CONSTRUCTION DRAWINGS FOX RUN NATURE CENTER

EPC STORMWATER REVIEW COMMENTS
IN ORANGE BOXES WITH BLACK TEXT

SHEET INDEX	
SHEET NUMBER	SHEET TITLE
C1	COVER
C2	EXISTING CONDITIONS & DEMO PLAN I
C3	EXISTING CONDITIONS & DEMO PLAN II
C4	SITE PLAN
C5	SIGNING & STRIPING PLAN
C6	DRIVEWAY & PARKING AREA GRADING PLAN
C7	BUILDING GRADING PLAN
C8	ROAD RECLAMATION GRADING PLAN
C9	WALL PLAN AND PROFILE I
C10	WALL PLAN AND PROFILE II
C11	WALL PLAN AND PROFILE III
C12	WALL PLAN AND PROFILE IV
C13	UTILITY SERVICES PLAN
C14	OFF-SITE WATER SYSTEM PLAN
C15	ON-SITE WATER SYSTEM PLAN
C16	OVERALL STORM SYSTEM PLAN
C17	ROOF DRAIN AND PATIO PLAN AND PROFILE
C18	POND PLAN AND PROFILE
C19	DETAILS

EL PASO COUNTY PARKS
FOX RUN NATURE CENTER
BUILDING GRADING PLAN

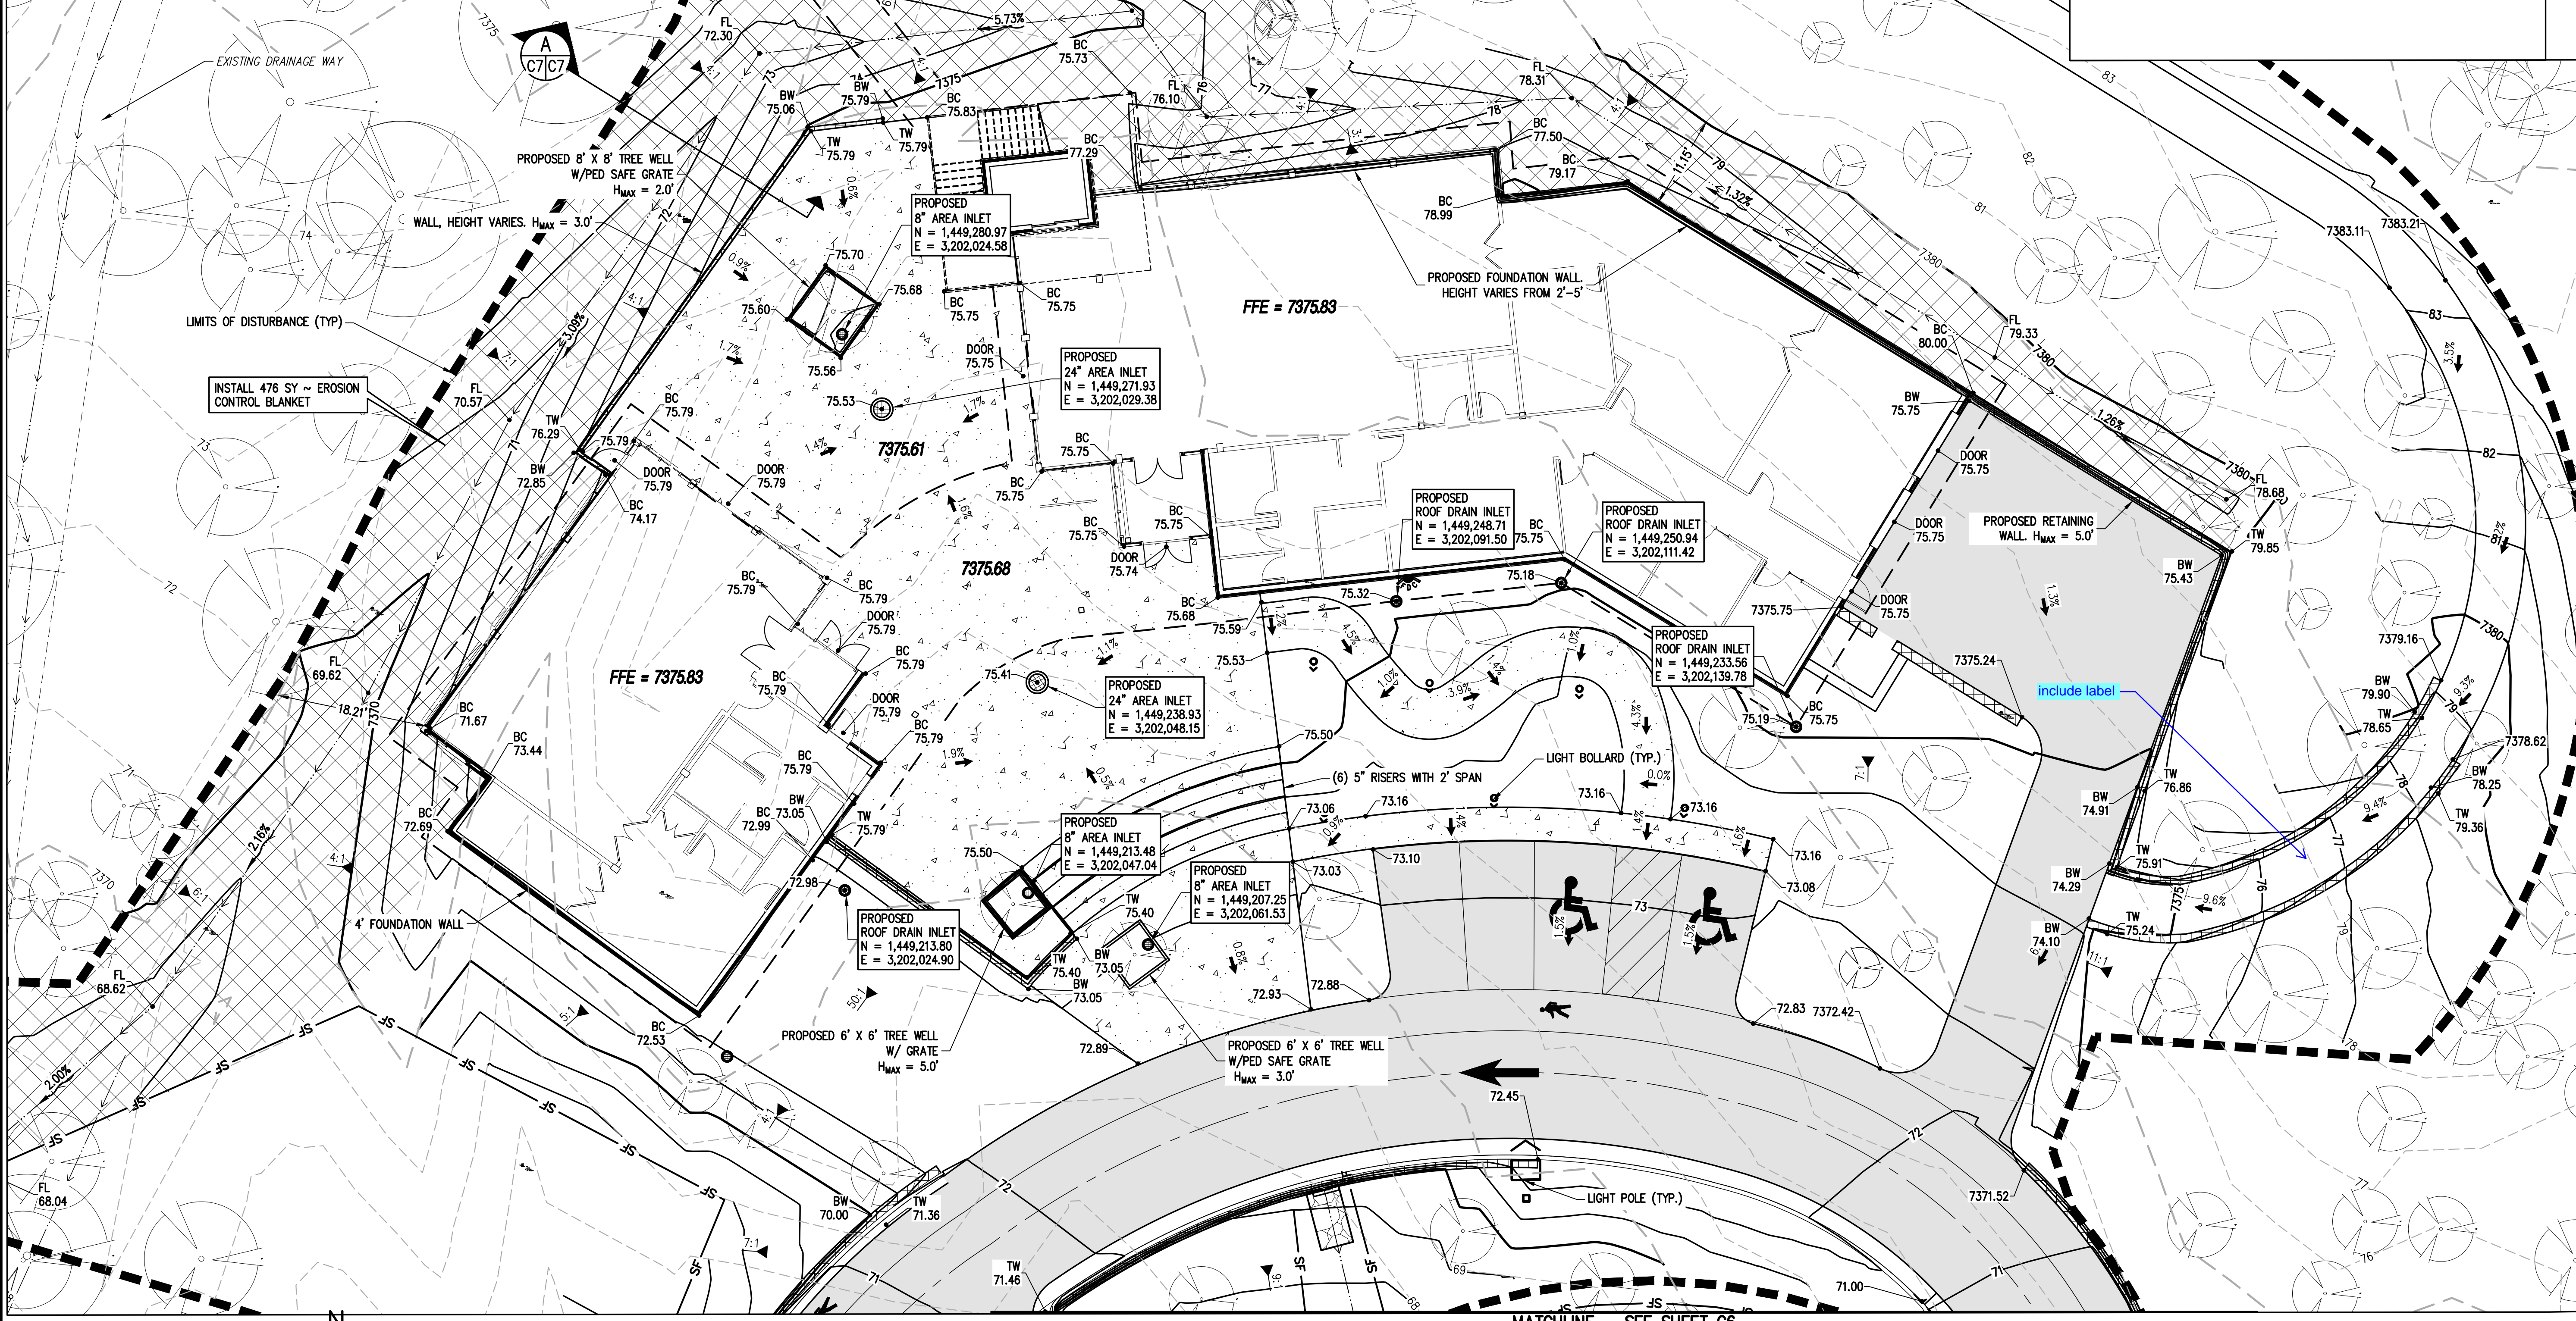
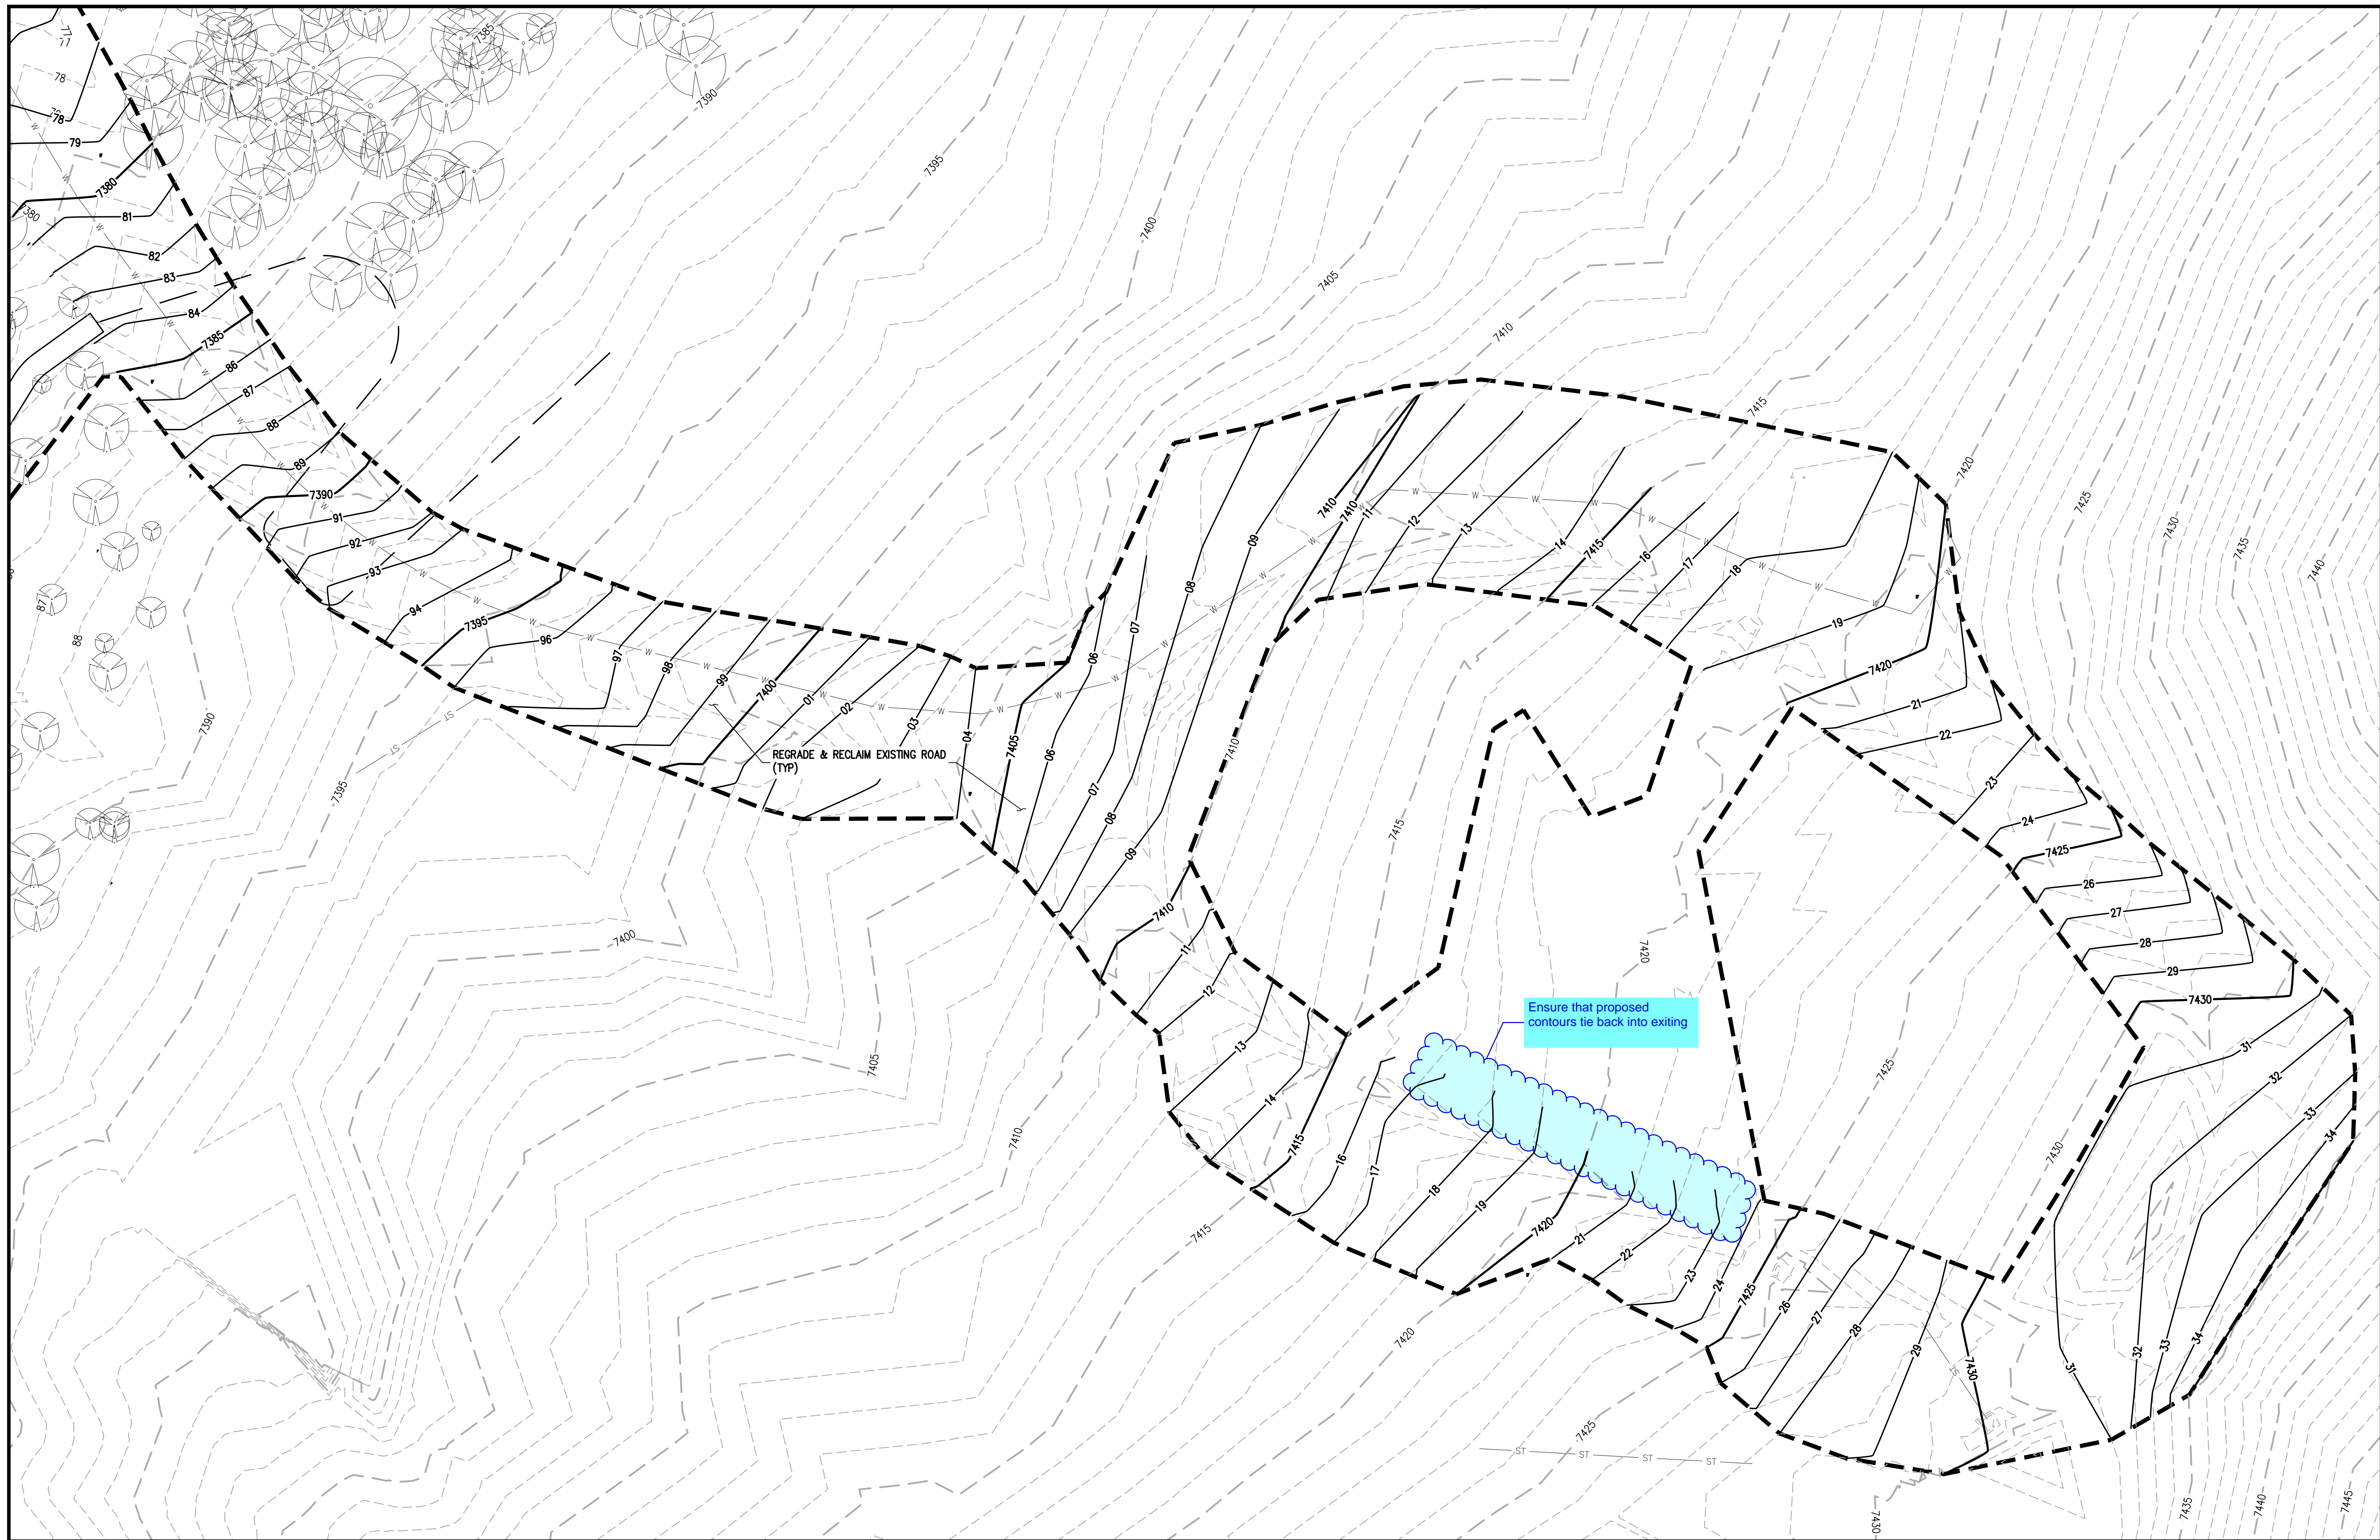
Please include all appropriate linework in the legend and turn off unneeded linework from this drawing
